Subject: SLIC Case RO0002942 and Geotracker Global ID SLT19735483, Sparkle Cleaners, 7000 Bancroft Avenue, Oakland, CA 94605 – Work Plan Approval

Alameda County Environmental Health (ACEH) staff has reviewed the Spills, Leaks, Investigations, and Cleanups (SLIC) case file for the above referenced site including the work plan entitled, "Remedial Action Workplan, Voluntary Soil Remediation, Sparkle Cleaners, Eastmont Town Center," dated January 5, 2007, and prepared by PES Environmental, Inc. Tetrachloroethene (PCE) is present at elevated concentrations in soil in the area of a former dry cleaning unit at Sparkle Cleaners. PCE was also detected in soil vapor and groundwater at concentrations that exceed applicable regulatory criteria. The Work Plan proposes excavation of soil beneath Sparkle Cleaners and groundwater monitoring following the soil remediation. The proposed scope of work is acceptable provided that the technical comments below are addressed and incorporated during the remedial action and groundwater monitoring. Submittal of a revised Work Plan is not required unless an alternate scope of work outside that described in the Work Plan or technical comments below is propos

# Revised Figure 4

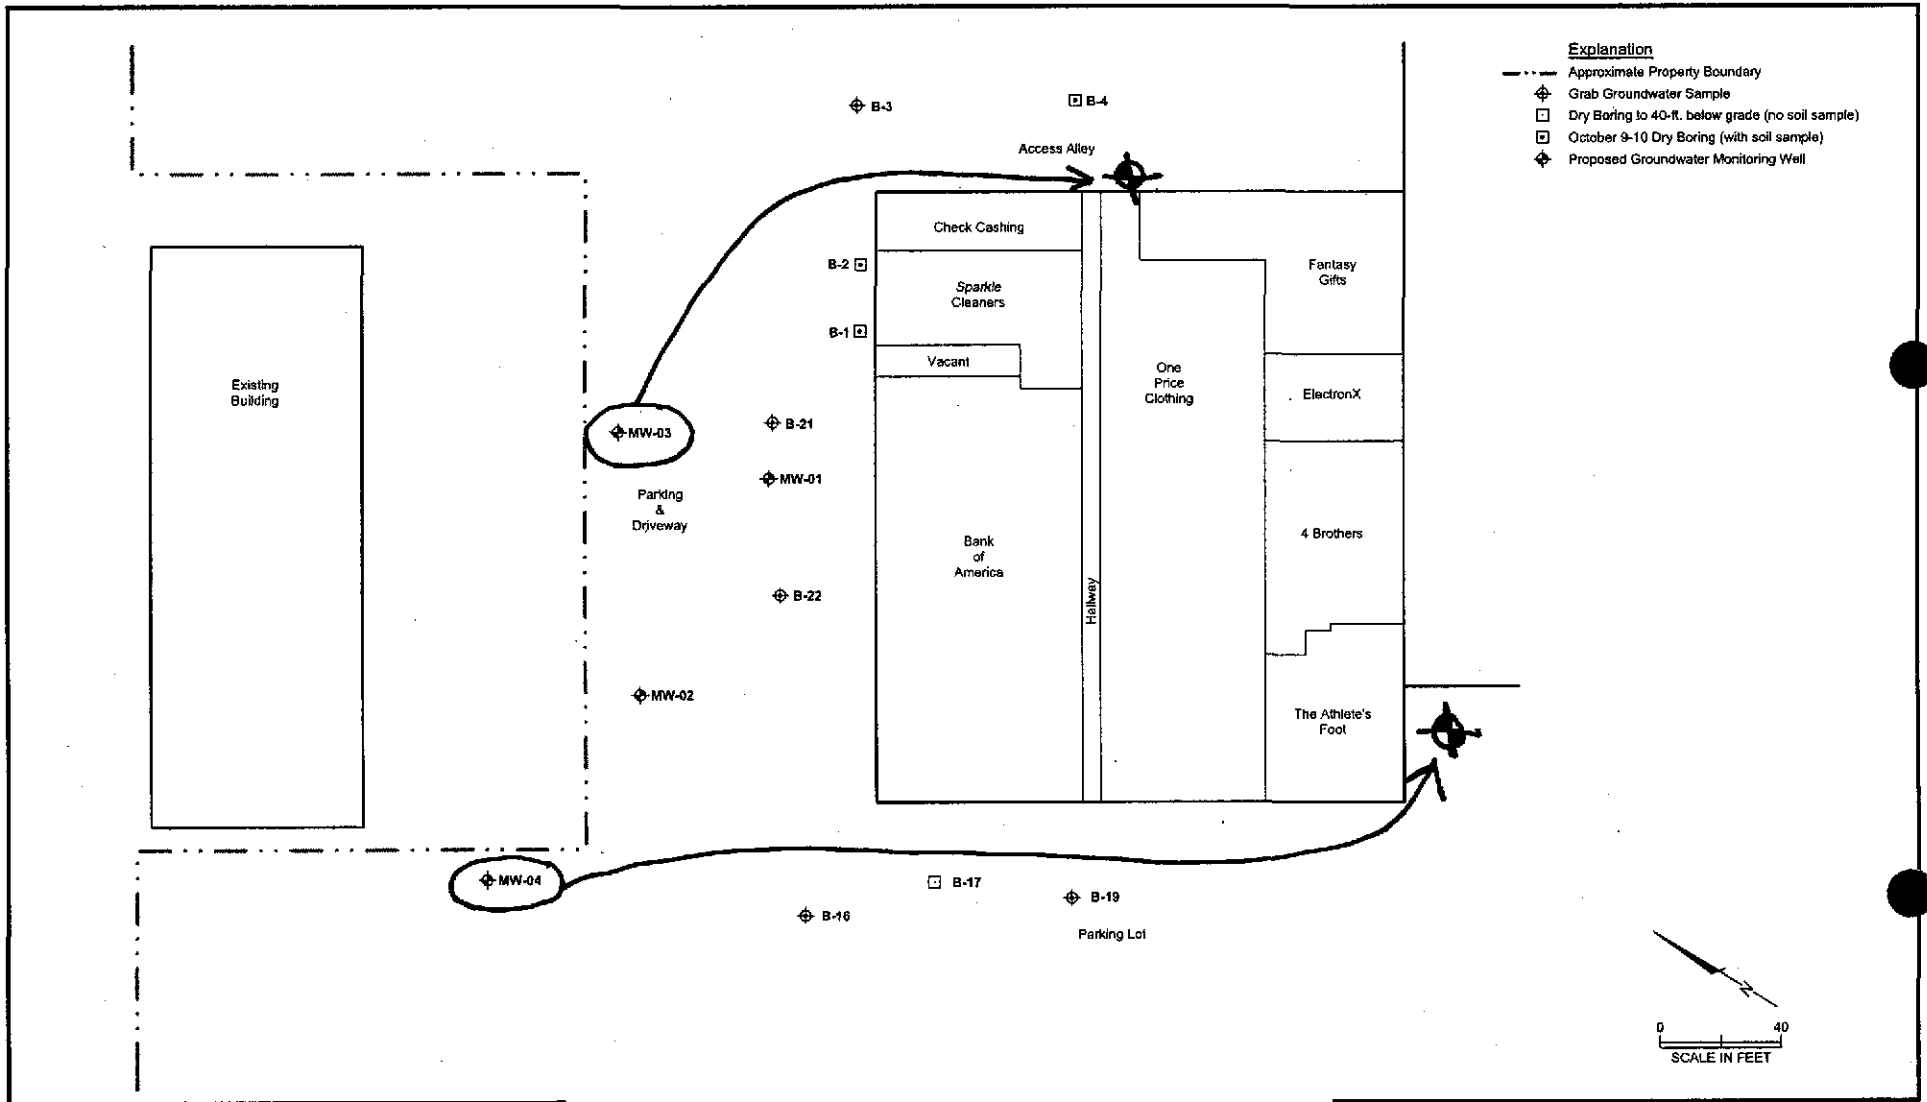
3. **Groundwater Flow Direction and Proposed Well Locations.** The apparent hydraulic gradient (west-northwest) observed during previous investigations at the site does not appear to be consistent with the expected regional groundwater flow direction. A west-northwest hydraulic gradient is also not consistent with the hydraulic gradients observed at two nearby fuel release sites at 7225 Bancroft Avenue and 7210 Bancroft Avenue. Four monitoring wells are proposed in the area west of Sparkle Cleaners. Due to uncertainty in groundwater flow direction for the site, we request that the proposed locations for wells MW-03 and MW-04 be revised as shown on the attached Revised Figure 4.
